Office Action Summary

10/566,290

YOON, HYUN-JAE

DETAILED ACTION

FIG. 1

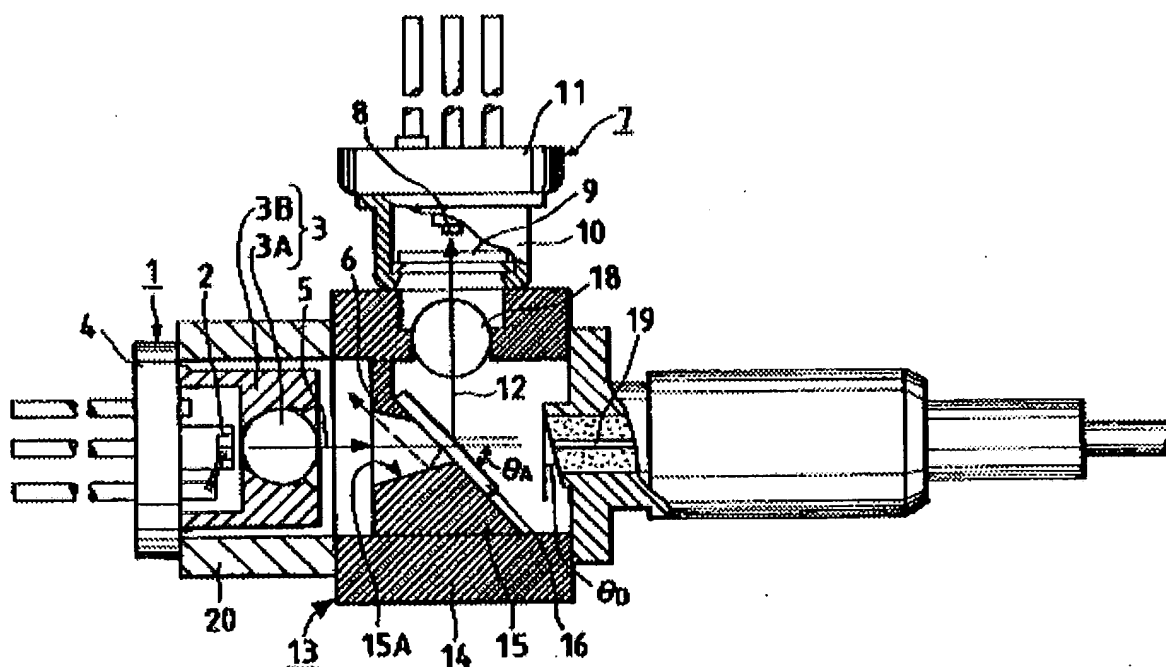
With respect to claim 1, Takahashi et al. (figure 1) disclose a bi directional optical module package having an optical module unit comprising a substrate member (14, 15); an optical filter (16) installed on the substrate member (14, 15) to be inclined with respect to an optical fiber (19); a first holder (20) supported by the substrate member (column 5, lines 28-29) on one side of the optical filter (16) and having a laser diode (2) and a lens (3A) for transmitting an optical signal to the optical fiber (19) through one side of the optical filter (16); and a second holder (see figure 1) supported by the substrate member (column 5, line 51) on the other side of the optical filter (16) and having a photodiode (8) and a lens (18) for receiving the optical signal received through the optical fiber (19).

With respect to claim 3, Takahashi et al. (figure 1) disclose the bi directional optical module package, wherein an optical axis of light transmitted from the laser diode (2) and an optical axis of light received from the photodiode (8) are disposed at right angle with respect to each other with the optical filter (16) being interposed therebetween (see figure 1).

With respect to claim 4, Takahashi et al. (figure 1) disclose the bi directional optical module package, wherein the first holder (20) includes a first base portion (4) having a laser diode (2), a pad and a circuit pattern installed thereon, and first extending portions which extend from both sides of the first base portion to define a fixed position of the lens, and the second holder includes a second base portion (11) having a photodiode (8) installed on an inner surface thereof, and second extending portions

which extend from both sides of the second base portion to define a fixed position of the lens (18).

With respect to claim 5, Takahashi et al. (figure 1) disclose the bi directional optical module package, wherein inclined planes for fixing a position of the optical filter (16) are formed on at least one side of the first extending portions and at least one side of the second extending portions (see figure 1).

With respect to claims 6 and 7, Takahashi et al. (figure 1) disclose a bi directional optical module package comprising an optical fiber (19) which is supported by supporting means (see figure 1); an optical module unit which has a substrate member

(14, 15), an optical filter (16), a first holder (20); and a second holder (see figure 1); the optical filter (16) being installed on the substrate member (14, 15) to be inclined with respect to an optical fiber (19); the first holder (20) supported by the substrate member (column 5, lines 28-29) on one side of the optical filter (16) and having a laser diode (2) and a lens (3A) for transmitting an optical signal to the optical fiber (19) through one side of the optical filter (16); and a second holder (see figure 1) supported by the substrate member (column 5, line 51) on the other side of the optical filter (16) and having a photodiode (8) and a lens (18) for receiving the optical signal received through the optical fiber (19); a stem which supports the optical module unit and has a plurality of pins (see figure 1).

With respect to claim 8, Takahashi et al. (figure 1) disclose the bi directional optical module package, wherein the first holder (20) includes a first base portion (4) having a laser diode (2), a pad and a circuit pattern installed thereon, and first extending portions which extend from both sides of the first base portion to define a fixed position of the lens, and the second holder includes a second base portion (11) having a photodiode (8) installed on an inner surface thereof, and second extending portions which extend from both sides of the second base portion to define a fixed position of the lens (18).

With respect to claim 9, Takahashi et al. (figure 1) disclose the bi directional optical module package, wherein inclined planes for fixing a position of the optical filter (16) are formed on at least one side of the first extending portions and at least one side of the second extending portions (see figure 1).
